UNITED STATES
NUCLEAR REGULATORY COMMISSION

February 15, 2000

SUBJECT: CONVERSION TO IMPROVED TECHNICAL SPECIFICATIONS FOR NINE MILE POINT NUCLEAR STATION UNIT NO. 2 - AMENDMENT NO. 91 TO FACILITY OPERATING LICENSE NO. NPF-69 (TAC NO. MA3822)

Figure 3.4.1-1 (Page 1 of 1)
Stability Monitoring Power-to-Flow Map

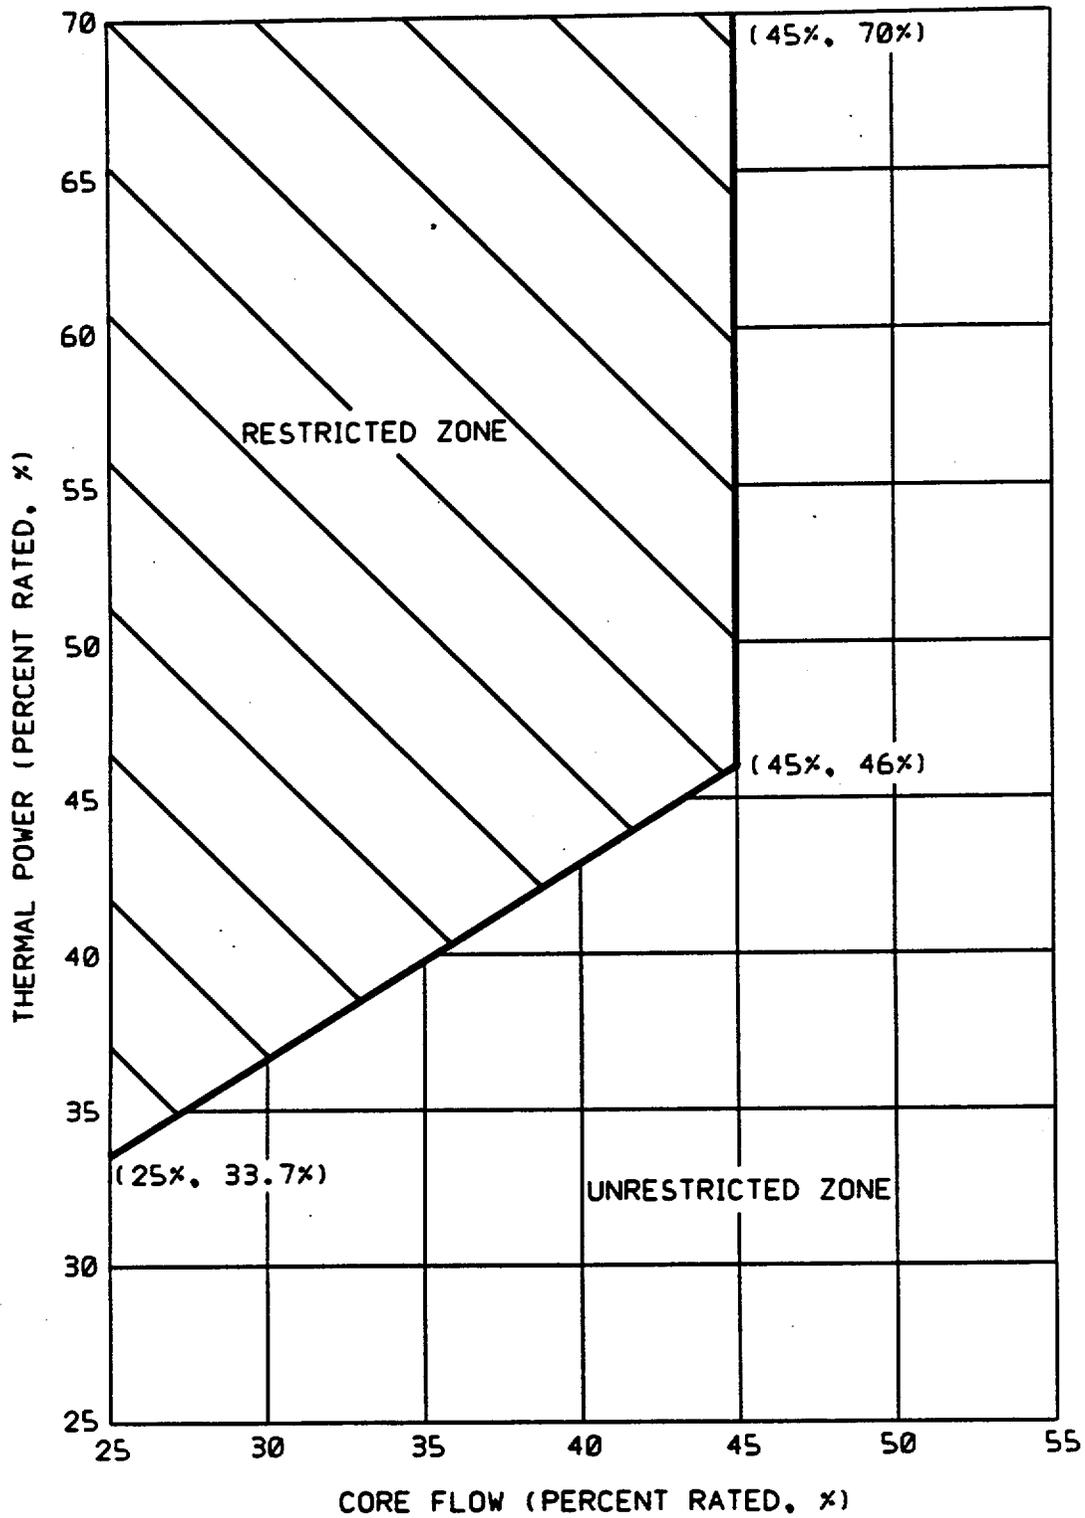
CTS 3.4.1.1.b requires the THERMAL POWER to be in the unrestricted zone of Figure 3.4.1.1-1. However, there is no Surveillance Requirement that verifies this requirement on a periodic basis. ITS SR 3.4.1.1 has been added to verify operation is in the "Unrestricted Zone" of ITS Figure 3.4.1-1 every 12 hours. This will ensure that entry into a region where potential instabilities can occur will not go undetected. Therefore, this change is more restrictive on plant operations and is acceptable.

SURVEILLANCE		FREQUENCY
SR 3.4.1.1	Verify operation is in the "Unrestricted Zone" of Figure 3.4.1-1.	12 hours
SR 3.4.1.2	<p>-----NOTE----- Not required to be performed until 24 hours after both recirculation loops are in operation. -----</p> <p>Verify jet pump loop flow mismatch with both recirculation loops in operation is:</p> <ul style="list-style-type: none"> a. $\leq 10\%$ of rated core flow when operating at an effective core flow $< 70\%$ of rated core flow; and b. $\leq 5\%$ of rated core flow when operating at an effective core flow $\geq 70\%$ of rated core flow. 	24 hours
